REQUEST FOR PLANNING COMMISSION ACTION

Meeting Date:		June 6, 2024					
Item Name:		PUBLIC HEARING - Variance (After-the-Fact) - 854 Beach Road					
Originating Department:		Community Development					
Presented by:		Lane Braaten					
Previous Commission Action (if any):

Item Name: SITE PLAN and DESIGN REVIEW - Goodwill Waconia

PHOTOMETRIC PLAN

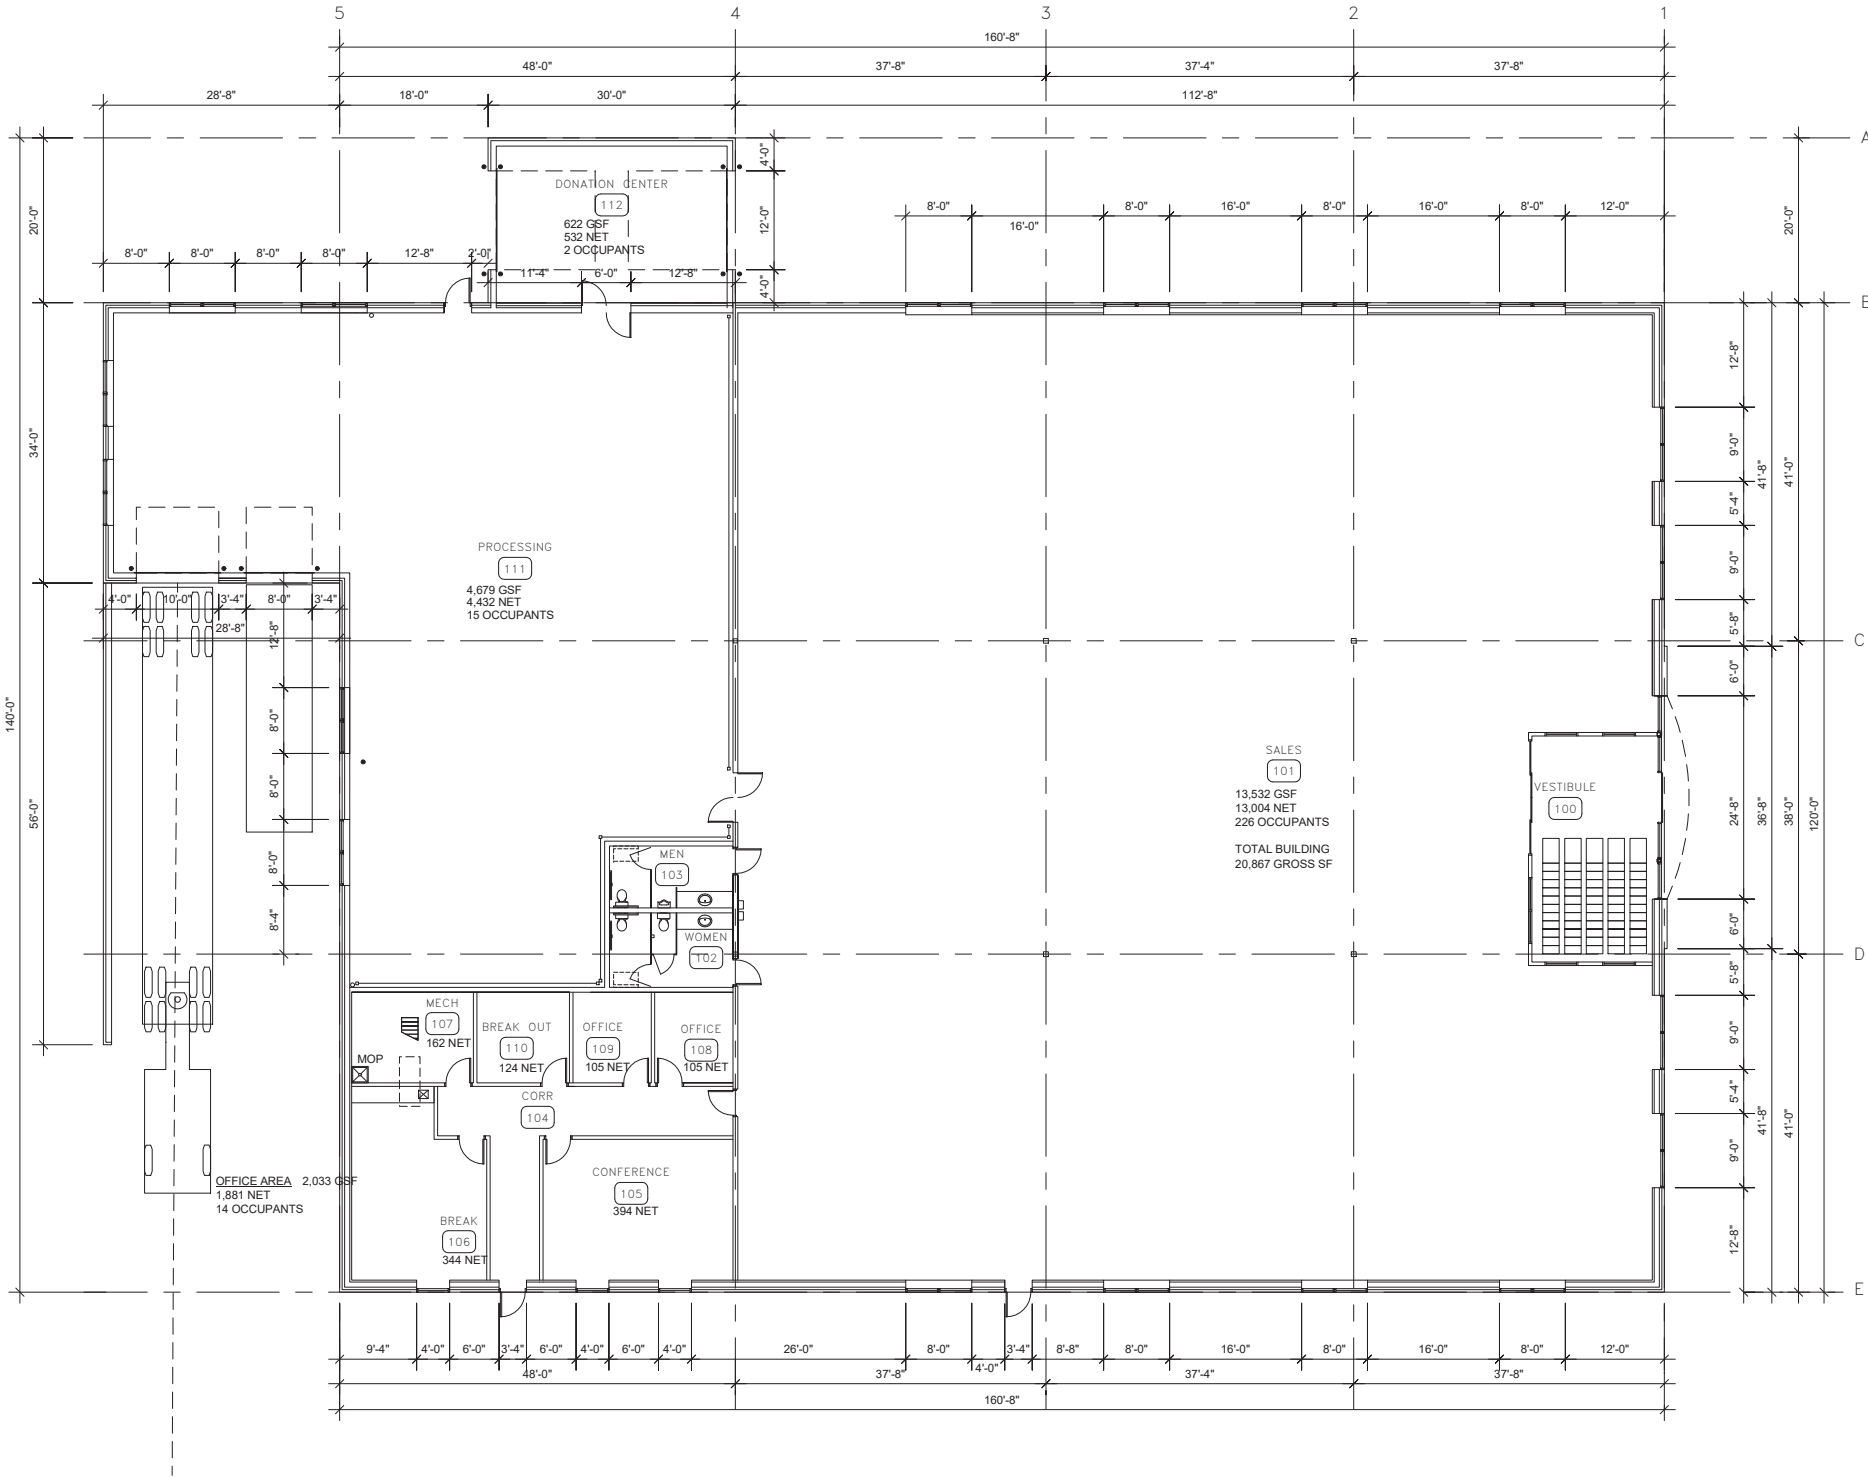
The lighting plan only complies with the standard stated above along the Hwy. 5 property line. The lighting plan shall be revised accordingly.

13. The lighting plan shall be revised to meet Section 900.08, Subd. 1.C. Specifically, light shall not exceed one (1.0) foot candle when the source of light abuts and commercial parcel or public right-of-way. Light poles and standards shall not exceed 35 feet.
